3 June 2025

RESPONSE TO HERITAGE VICTORIA'S REQUEST FOR FURTHER INFORMATION Junction Oval, St Kilda (1 Lakeside Drive, St Kilda) Permit Application P40484

Figure 1: Sightline diagram demonstrating the extent of obstruction to those sitting to the front (red cone) and rear (maroon cone) southernmost seats of the Kevin Murray grandstand.

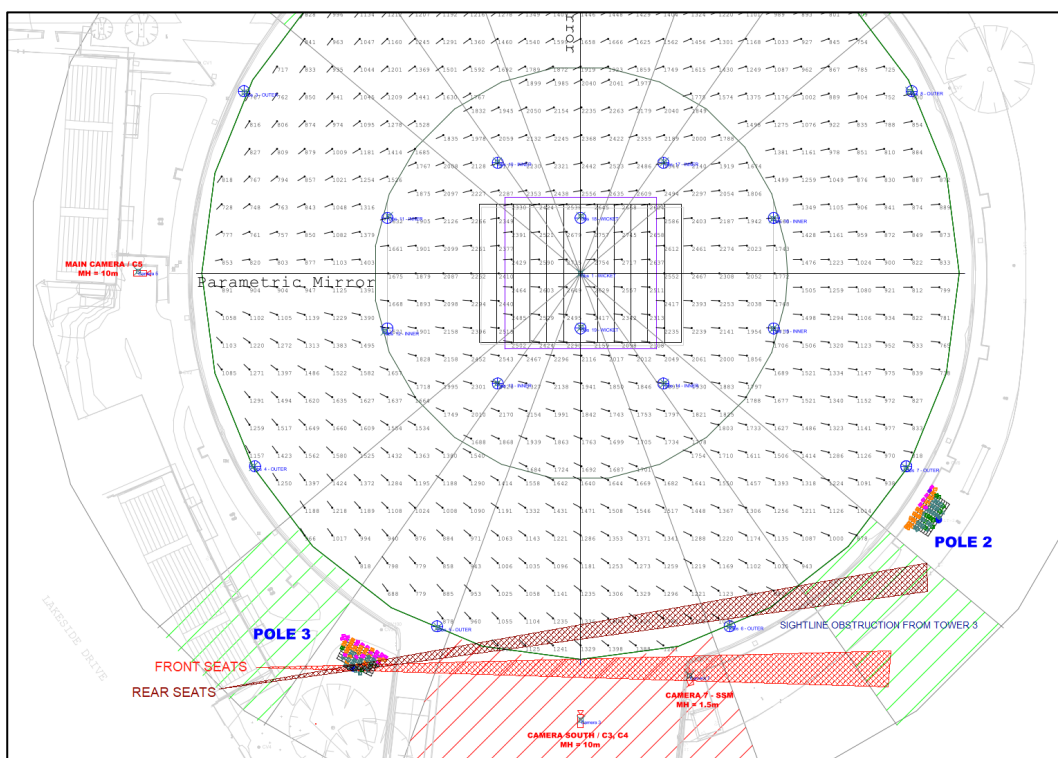
In consideration of the request for a render demonstrating the visual impact of Tower 3 from inside the Kevin Murray Stand (B1), the following sightline diagram has been prepared.

As demonstrated by the above sightline diagram, light tower 3 will only marginally impact oblique views from this grandstand in the southernmost seats, at the rear of the grandstand. For the balance of the grandstand, the light tower will not intersect any sightlines towards the oval regardless of the seated position of any spectators.

The only instance in which sightlines from the grandstand to the oval will be impacted is for those sitting in the southern most seats, at the rear. The sightline depicted from the rear seats in Figure 1 demonstrate the maximum vision obstruction from these seats, being measured not from a natural seating posting, but rather sat as far south,

and as recessed as possible. Even in these constrained circumstances, any impacts to sightlines are nominal and will not impact the appreciation of the oval to any material degree. Further to this and given the limited diameter of the tower (1.62 metres) it is considered that the impact is comparable to the wooden columns of the Kevin Murray Grandstand itself. We trust that this justification is acceptable in lieu of the preparation of a third visualisation.

View 06 - Proposed Built Form

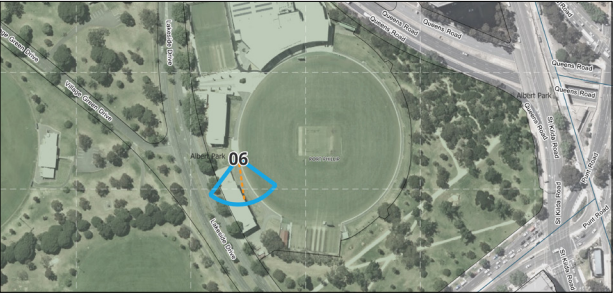
2. Additional renders to demonstrate the visual impact of the placement of lighting tower 3 on the Kevin Murray Stand.

- View taken between B1 & B2 from the oval fence line looking toward the Kevin Murray Stand.
- View taken from lighting tower 2 looking toward the Kevin Murray Stand.

It is considered that these photos further demonstrate the limited visual impact of these towers to the heritage fabric of the place given their siting and the limited diameter of the poles.
